**City of Columbus
NOTICE OF PUBLIC HEARING
ALTERNATIVE MEETING FORMAT
(Statutes Section 13D.021)
Conditional Use Permit Amendment**

APPLICATION FOR CONSIDERATION OF: CONDITIONAL USE PERMIT

Proposed CUP Amendment

RE: Bare Home (JP Commerce) Conditional Use Permit Amendment

4 SOUTH EXTERIOR ELEVATION
 A300 1/16" = 1'-0"
 Revision 11.25.2019

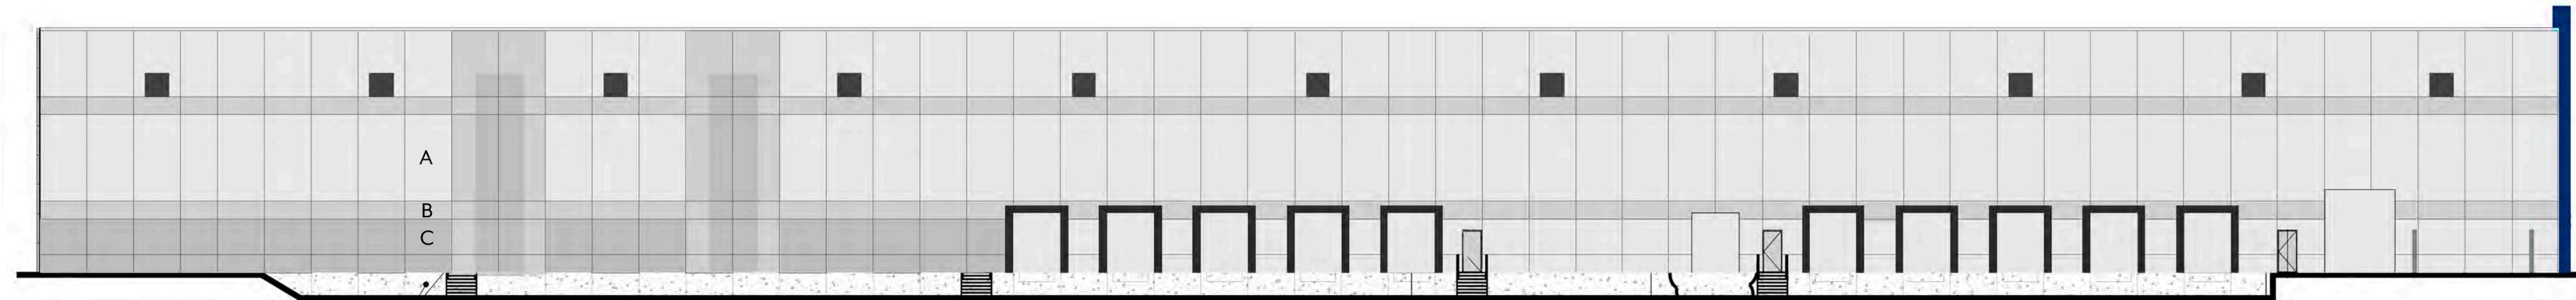
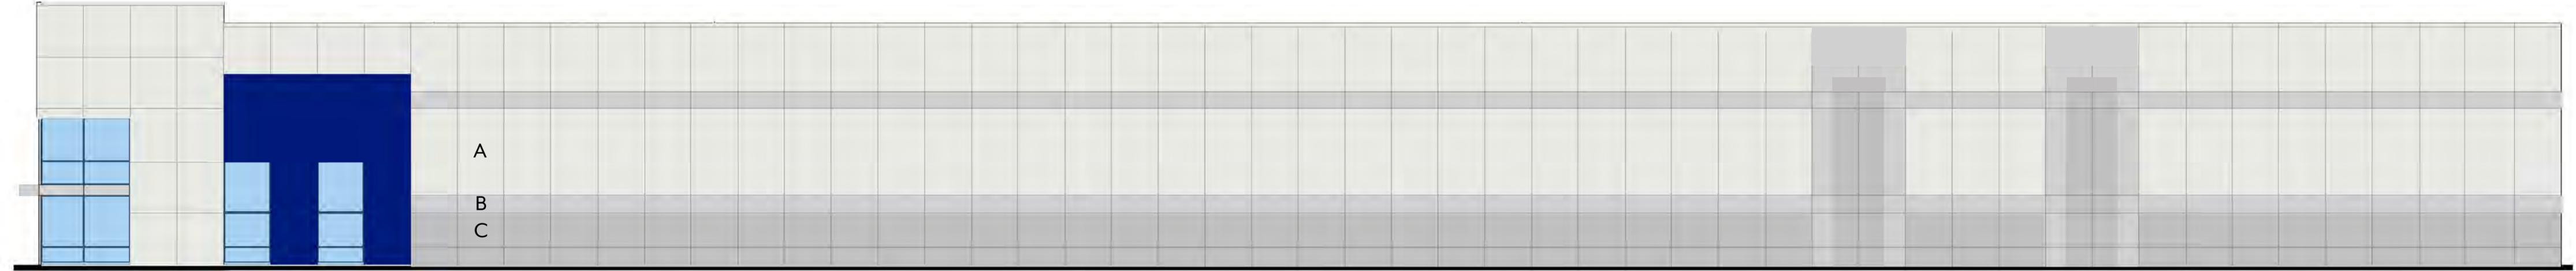
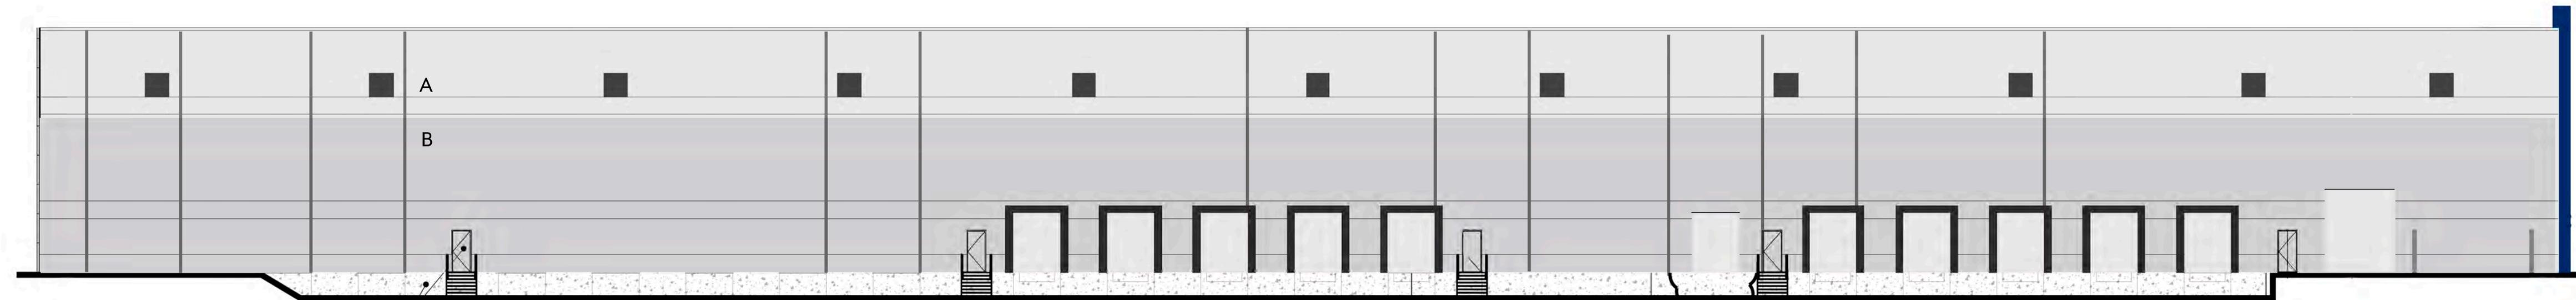
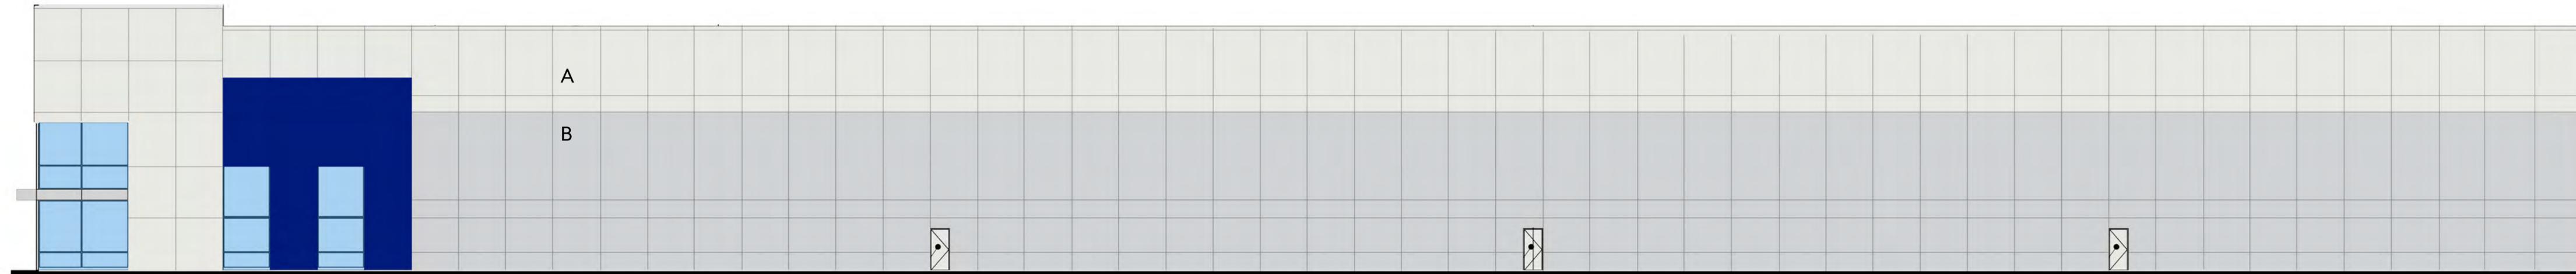
The proposed amended design for the exterior of Bare Home Headquarters was initiated to align with the feedback from the city to soften the brightness of the existing structure so that it feels more a part of the surrounding environment, while maintaining the Bare Home™ brand and architectural integrity of the building design.

The previous design submitted on 11.19.2019 and approved by the City Council on 11.25.19 was created prior to having staff with significant design/build/architecture and brand experience. Upon review through this new lens, the paint design with horizontal and vertical striping that was approved created numerous visual interruptions in the architecture that were not considered when the building was designed, and therefore did not look intentional, but rather extraneous in their placement. In addition, the four different colors on the facade, including the blue for the brand architectural feature, created visual noise to what was designed to be a simple and clean structure.

This new revised paint design covers over $\frac{2}{3}$ of the structure with a single gray band, from the ground up to the baseline of our logo, which tones down the off-white of the building significantly without introducing new design elements that are not unified with the building design. The off-white will only be on the upper third of the structure. The paint colors themselves remain the same but the proportions flip completely. (See proposal for paint swatches)

6. The Property is currently zoned Commercial Showroom (C/S).
7. The original CUP was approved on October 10, 2018. The first Amendment to the CUP, approved on November 25, 2019, allowed a change to the building elevation from an approved pre-cast exposed aggregate building exterior to a smooth pre-cast painted panel, painted in three colors, one white tone and two gray tones, arranged as pillars on the North, West, and South elevations. The purpose of this CUP amendment is to allow another change to the building elevation from the three-color pillar design to a two-color design, white and gray. The proposal is to break the building into thirds on the North, West, and South elevations, with the bottom two thirds painted gray with a large band of white wrapping the top third. Additionally, the Phase I landscape plan dated October 8, 2019 is being revised to replace nine (9) service berries and twenty-one (21) dwarf arctic willows with twenty (20) service berry trees on the West Elevation.

8. The East elevation is not changing from the approved November 25, 2019 building elevations.
9. The blue metal accent and sign, approved in 2018, will also remain as approved.

11. The proposed amendments to the building elevations are consistent with Section 7A-775 of the City Code regarding C/S District Design Standards.
12. The narrative, received 05.11.20, suggests that the landscape plan dated 06.04.20 has been updated to compliment the proposed amended elevation design. The twenty (20) Service Berry trees will break up the bottom one third of the West elevation, and with the addition of meadow prairie plantings Bare Home proposes this will further blend the building into the surrounding environment and continue to support the company’s pollinator friendly initiatives. It appears this revision also facilitates improved visibility of the blue Bare Home sign.
13. The Planning Commission held a public hearing on the Bare Home CUP Amendment Application on June 17th, 2020.

1 WEST SIDE BUFFER PLAN
1" = 20' - 0"

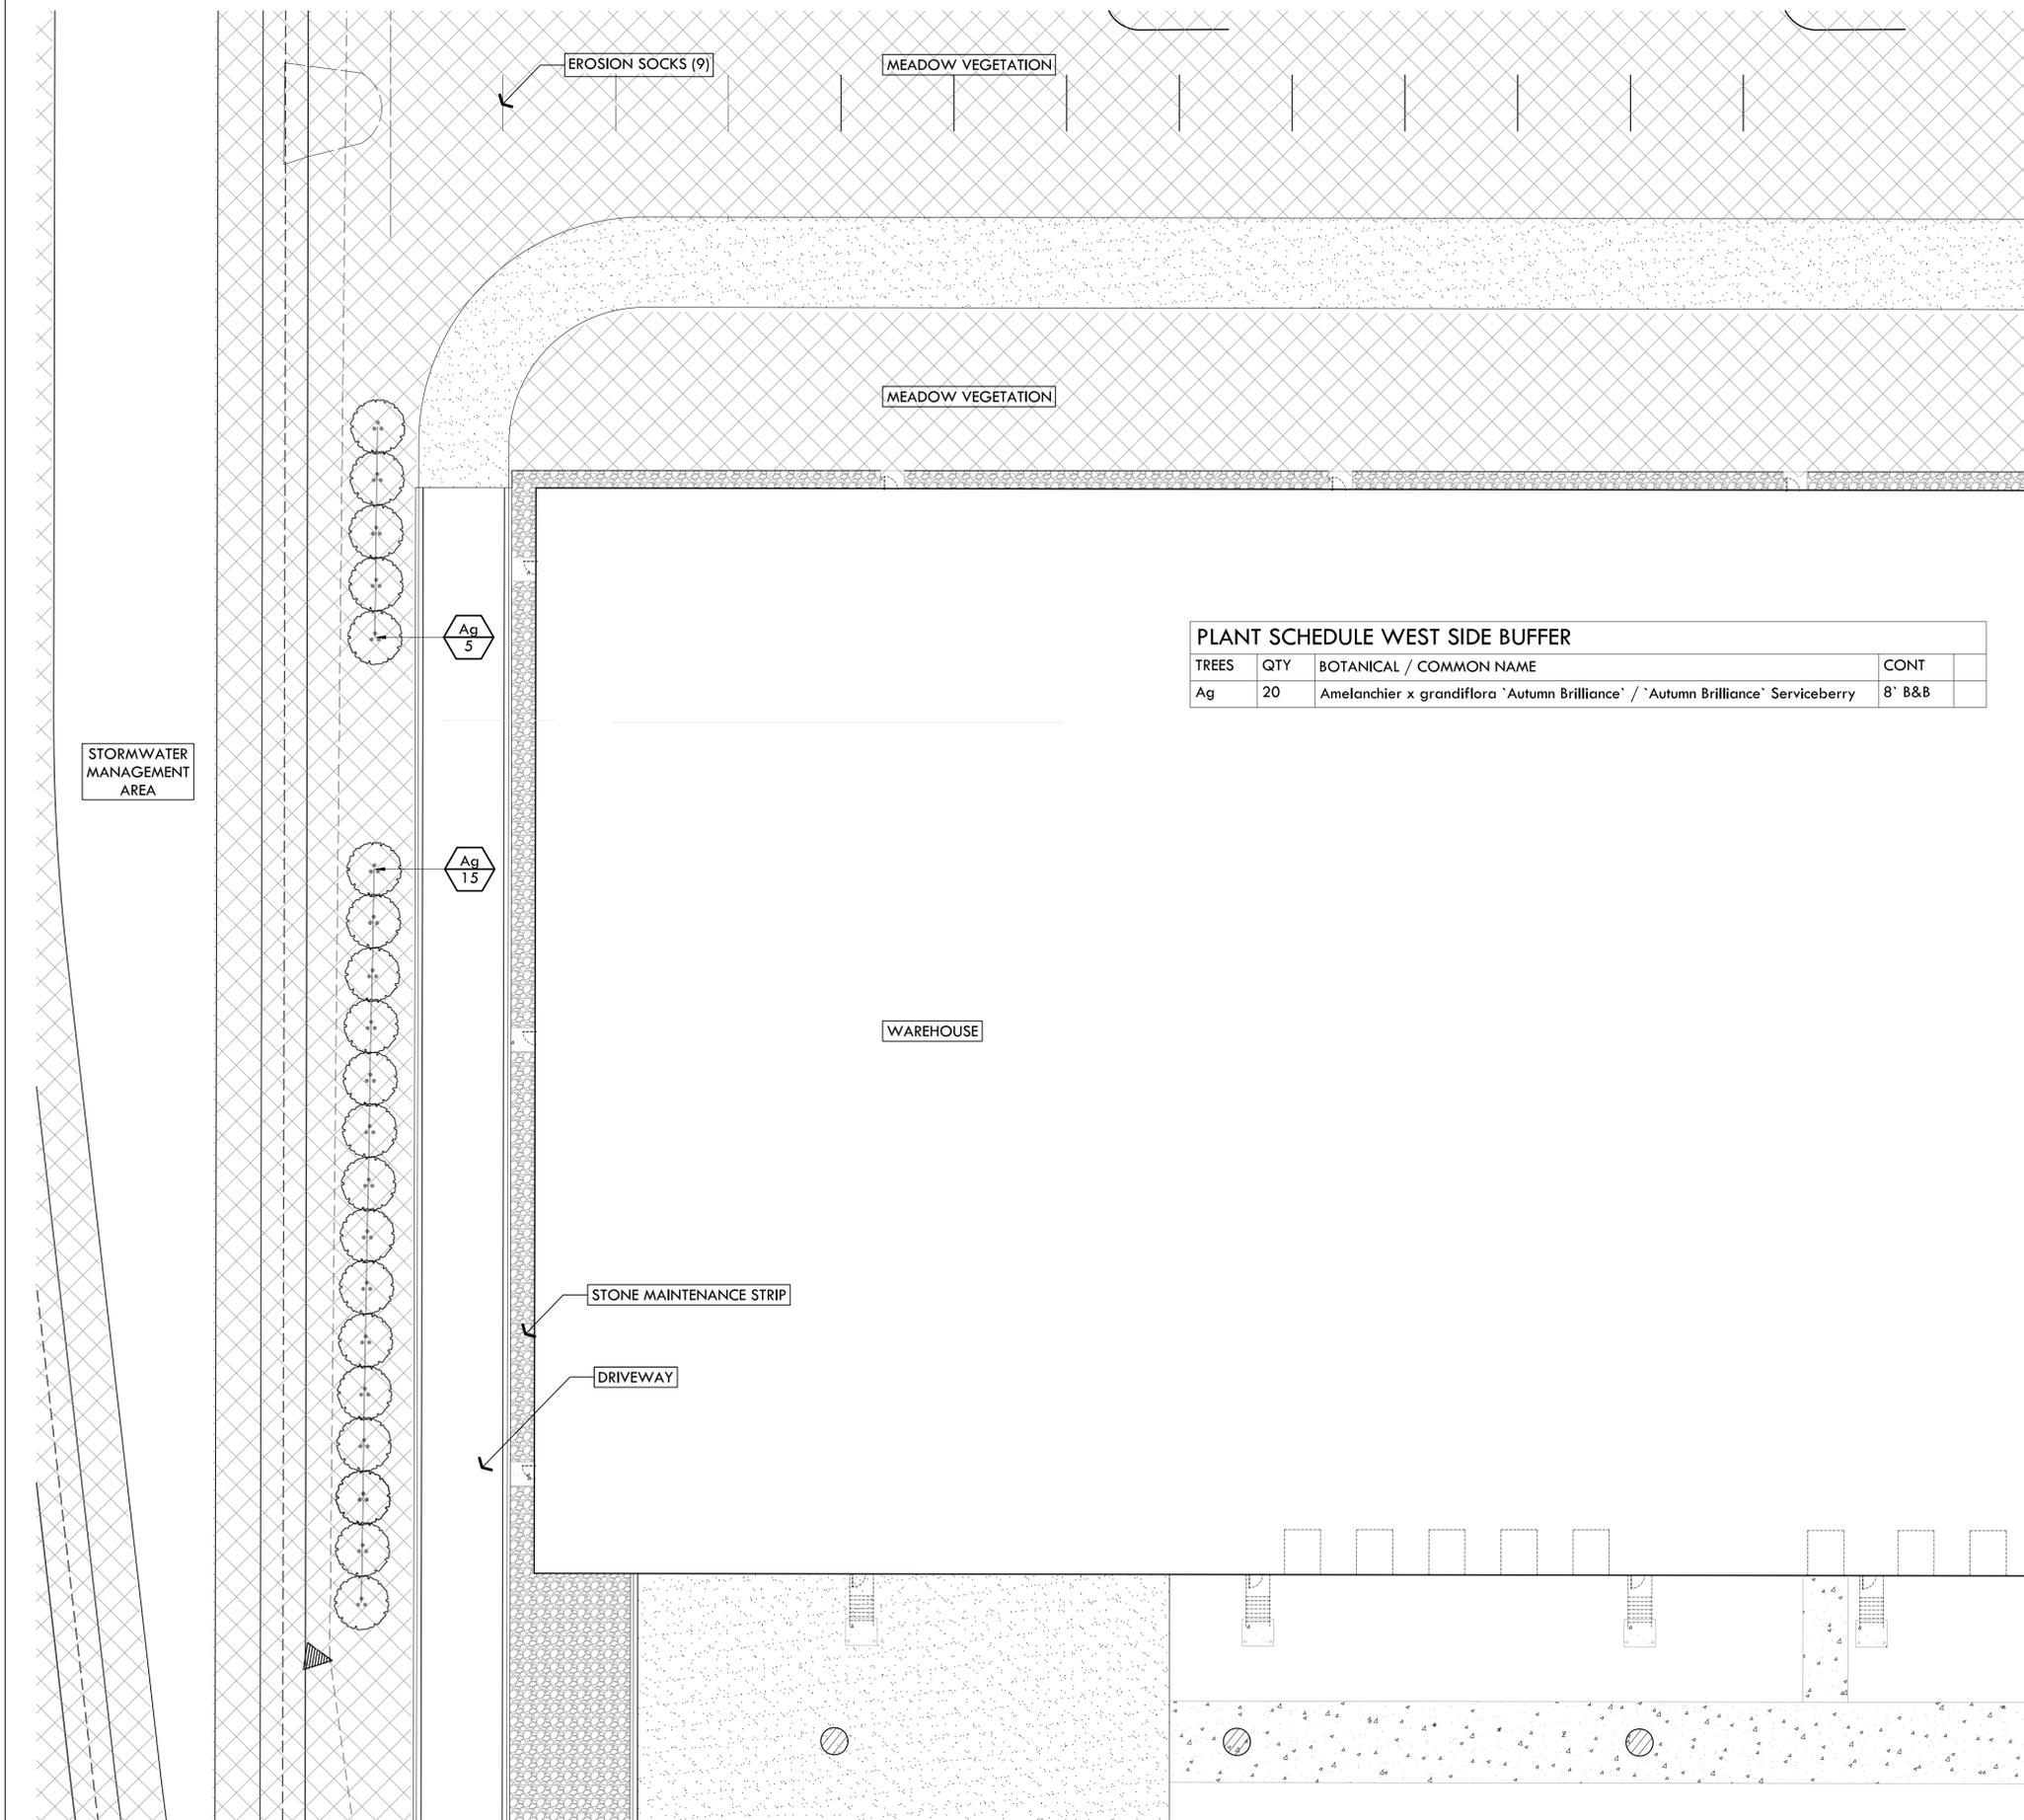
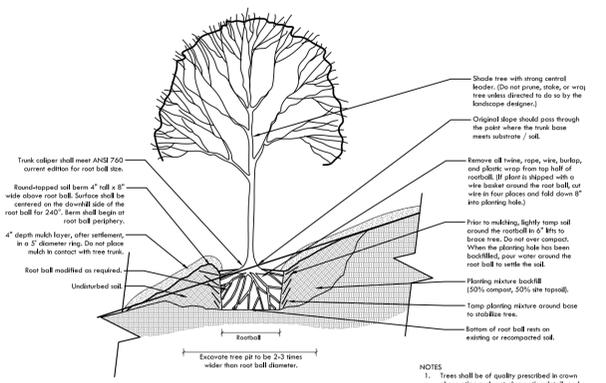
In addition to the painting and part of our ongoing sustainability initiative, we plan to add more landscaping along the entire West side of the building including mature native trees (see landscape plan addendum) which will be appropriately staked for stability, and the slope will be covered in meadow grasses and wildflowers. This will dramatically soften the bottom $\frac{1}{3}$ of the structure and help to blend the building even more with the surrounding environment. Even in the Winter, the trees will create a visual screen to strike a more harmonious balance with the surrounding landscape.

As seen in the amended landscape plan, the grounds on the North and West sides will all be surrounded in this natural meadow attracting pollinators, which means less irrigation and no mowing. The concern was raised about maintaining a lighter color building without discoloration

from irrigation,etc., and the low-maintenance meadow will help reduce this issue. We will also be maintaining the exterior regularly to prevent any discoloration.
